# INDIANA DEPARTMENT OF TRANSPORTATION

## APPROVED MINUTES

October 21, 2010 Standards Committee Meeting

RE: Minutes for the October 21, 2010 Standards Committee Meeting

706-CBRT-01 BRIDGE RAILING TRANSITION WBC OR TBC DETAILS AT END BENT (REVISED DRAFT)

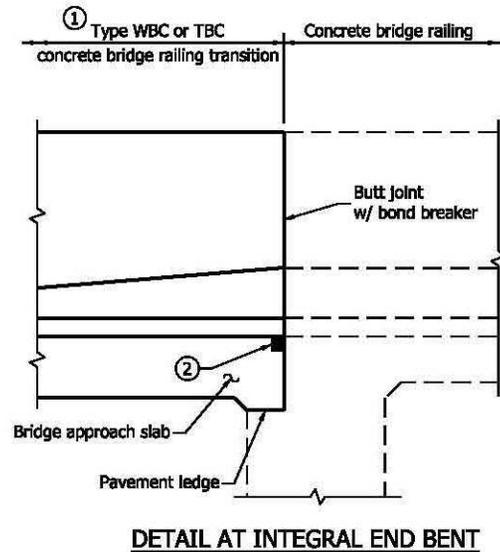
PROBLEM(S) ENCOUNTERED: There are no standard details for the section of concrete bridge-railing transition above the mudwall for the TBT, or truck-height, transition. The existing such standard details for the WBC or WBT, or common-height transitions, show a reinforcement pattern which does not match that in the main portion of the transition.

PROPOSED SOLUTION: Develop standard details for the mudwall portion of the TBT transition, and modify the existing details for the WBC and TBC transitions, so that the reinforcement pattern in the mudwall portion matches that in the main portion.

Introduced and presented by Mr. Uremovich.  
 Need to make the diagram show the bar as vertical, not horizontal. (586)

A couple of revisions to be made to clarify details. This will be accomplished by Mr. Uremovich.

706-CBRT-0302 BRIDGE RAILING TRANSITION WBC ATTACHMENT OF GUARDRAIL

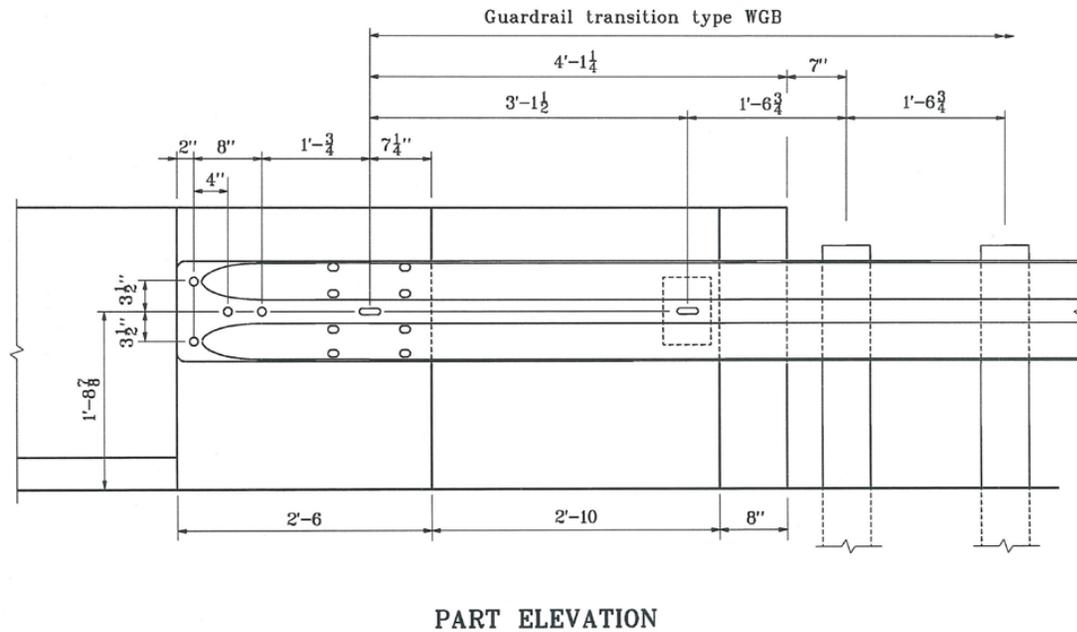
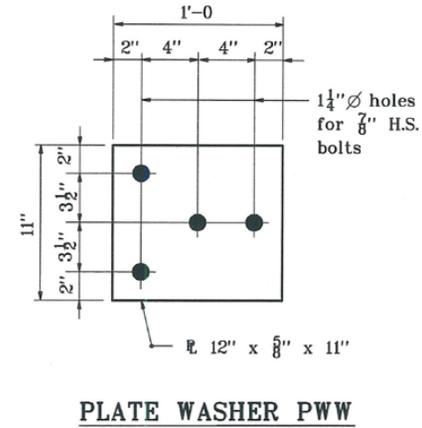
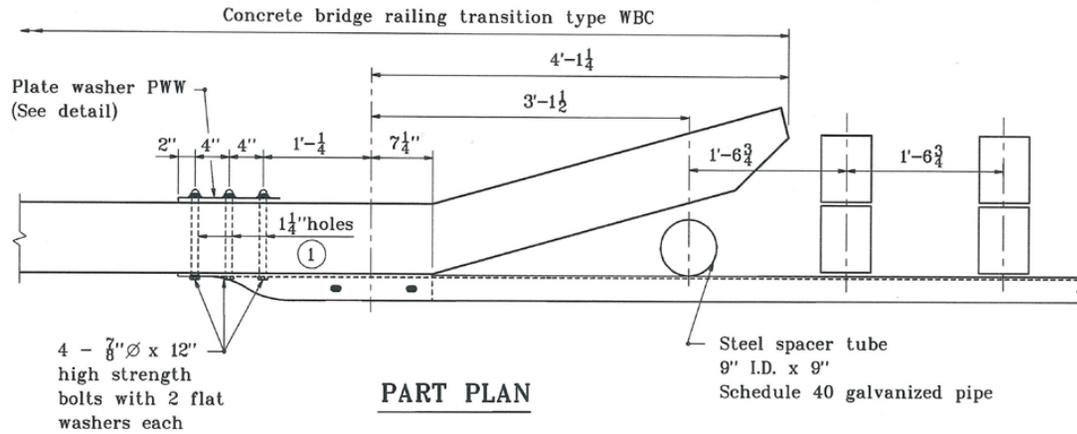
APPLICABLE STANDARD DRAWINGS: Revise 706-CBRT-01 for WBC and TBC transitions; add new 706-CBRT-03 for TBT transition; change existing 706-CBRT-02 to -04 and 706-CBRT-03 to -02 for drawings-series-order logic.
